To: Auburn Planning Board

From: David Hediger, Director of Planning

Re: 45 Flightline Drive: UPS Temporary Overflow Parking Lot: The Planning Board will hold a PUBLIC HEARING, review, and act on a Site Plan Review and Special Exception application submitted by Wentworth Partners & Associates on behalf of United Parcel Service (UPS) to establish a temporary gravel overflow parking. The site is located at 45 Flightline Drive (Parcel ID 131-007) within the Industrial zoning district and is subject to Chapter 60, Article XVI, Division 2 – Site Plan Review and Division 3 – Special Exception.

Date: August 14, 2025

PARKING LOT DETAIL 2
SCALE: 3/4" = 1'-0" C100

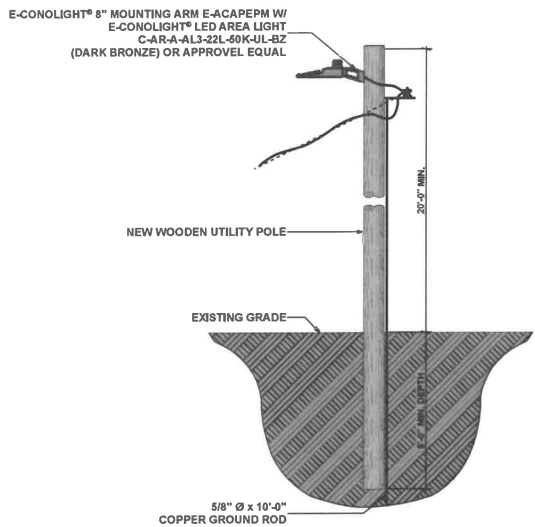
- *Gravel is noted, but staff recommends addressing erosion and stabilization. Alternatives such as reclaim should be evaluated and BMPs specified in your plan. Engineering is still recommending that the parking lot be paved, and gravel will only be allowed at the discretion of the Planning Board.*

A. This application is seeking to replace an existing gravel parking lot on the same property with a two-year temporary seasonal use parking area. Erosion and stabilization are addressed on the Construction Plans sheets C000 and C100 as well as with the specific material callout. Furthermore, the use of any petroleum-based materials for this application completely contradicts the intentions of part 2 above.

PROPOSED SITE PLAN 1
SCALE: 1" = 30' C100

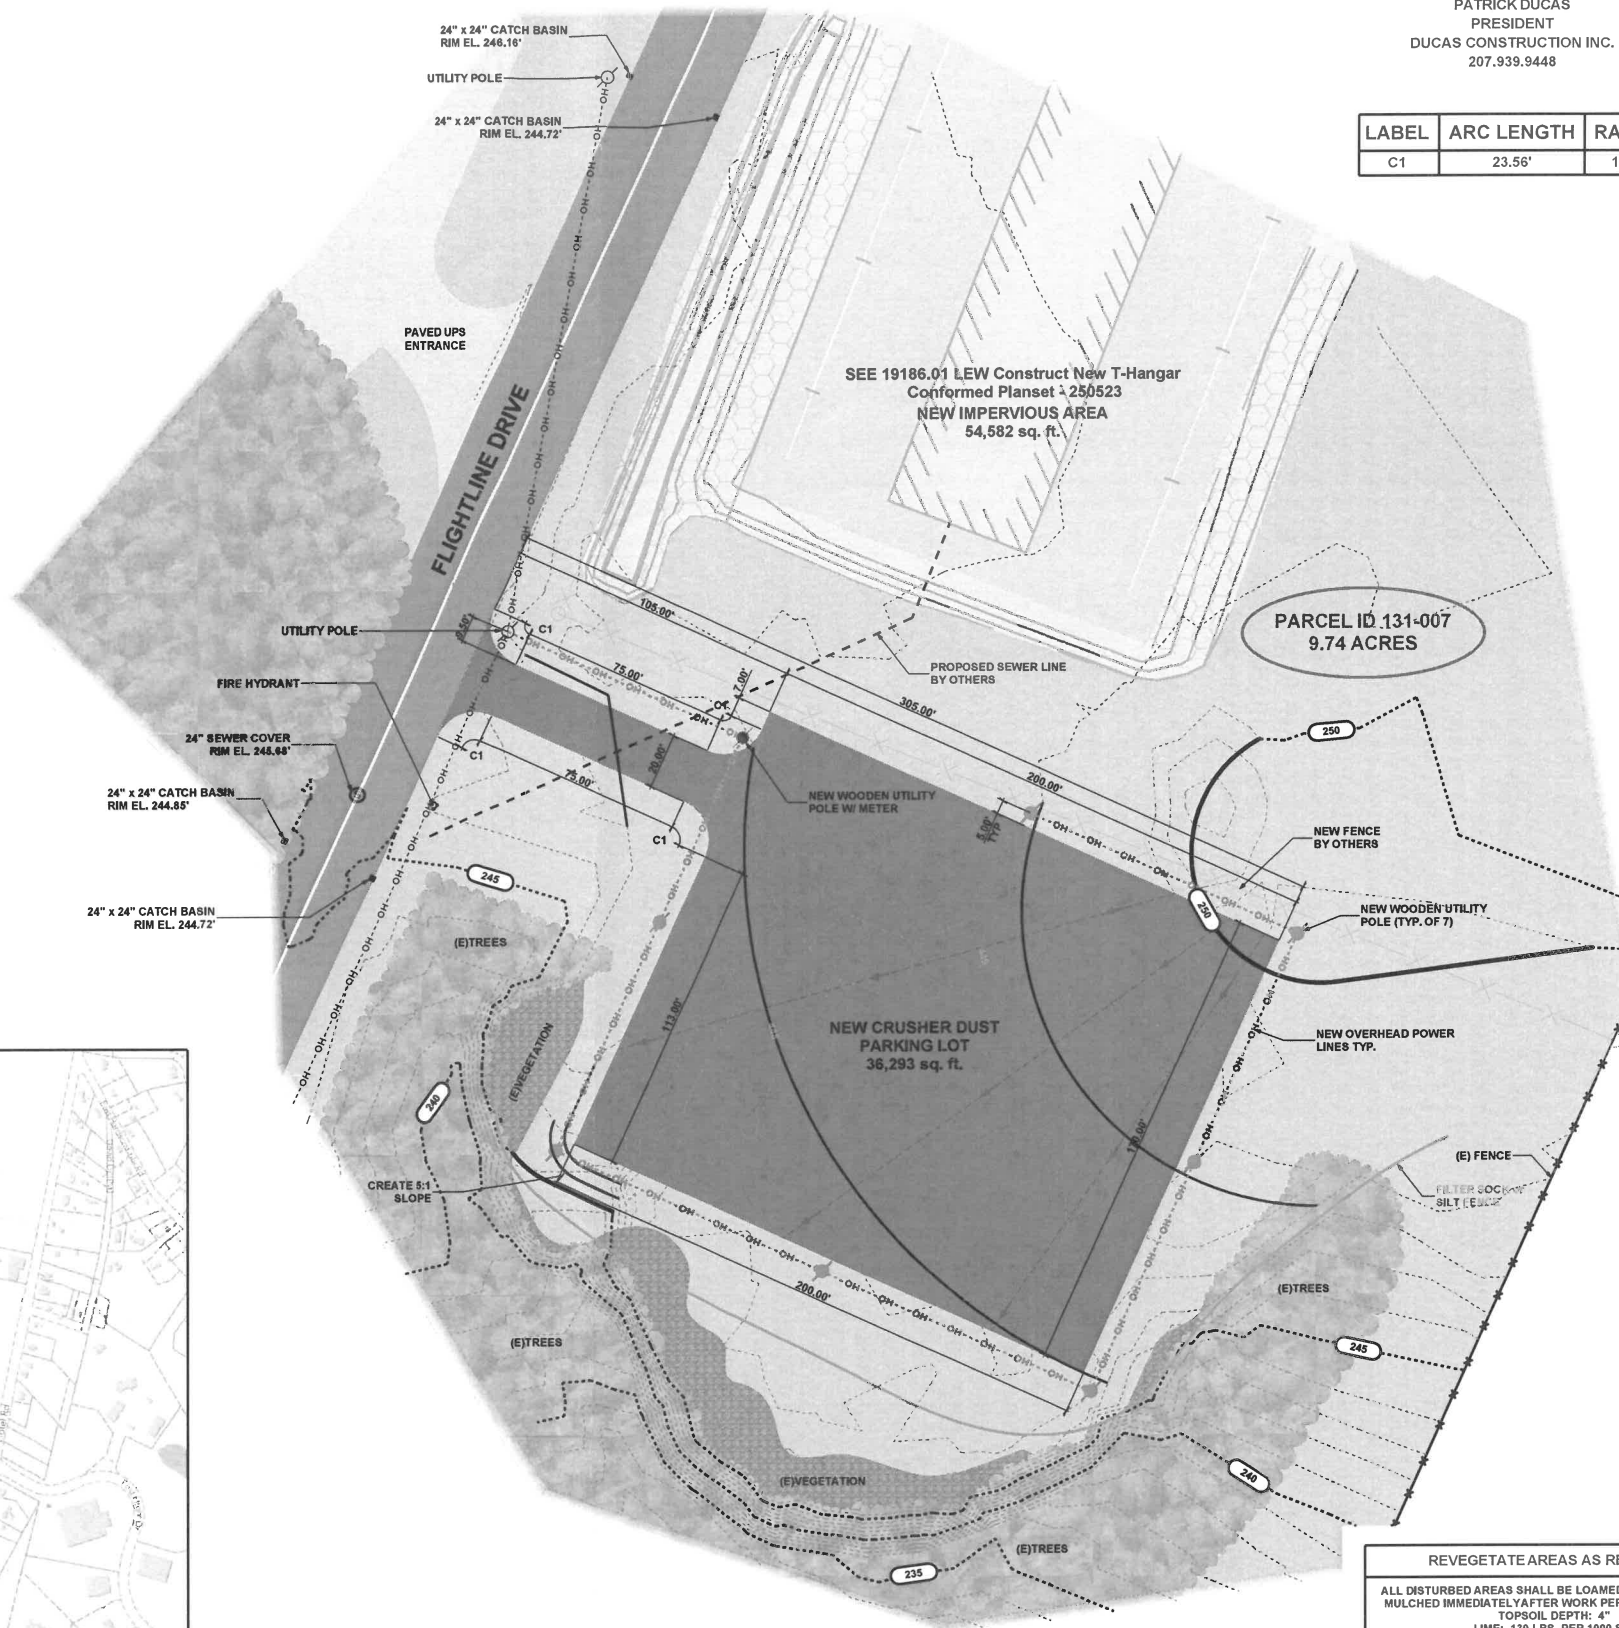
- *A fence is noted "by others." Please clarify:*
 - *Who is installing it?*
 - *When will it be installed?*
 - *Is it temporary or permanent?*

- *Please confirm whether any lighting is proposed. If so, a basic lighting plan must be provided.*
-

A. A basic lighting plan is part of this submittal, specifying the light fixture and spacing.
